May 2, 2022

Sites: Preserve at Woodmont - NMR1004NN - C09E015

Re: Drainage Ordinance (14-5-2-11) Violations for Erosion and Sediment Control

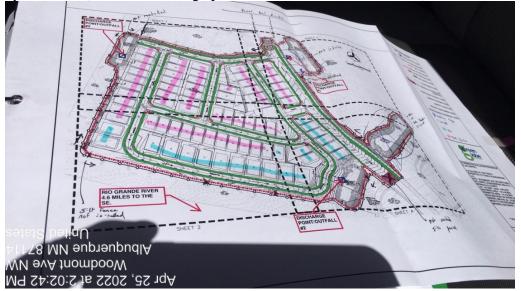
1. About 4 acres of land-disturbing activity has commenced without an ESC Plan and Property owner's NOI approved by the City of Albuquerque (1st Violation Notice.) According to images from Google earth the initial land disturbing activity began before 11/2015.

Additional grading of Woodmont shows up in the 10/2020 image.

- 1. The Erosion and Sediment Control Plan and the property owner's NOI were reviewed by the City and found to be satisfactory for grading approval, but the BMPs and Stabilization specifications were missing in the offsite Work Order (WO) portion of the site and must be provided for approval prior to approval of the Building Permit and the WO.
- 2. You must post a sign or other notice of your permit coverage at a safe, publicly accessible location in close proximity to the construction site per CGP Part 1.5.
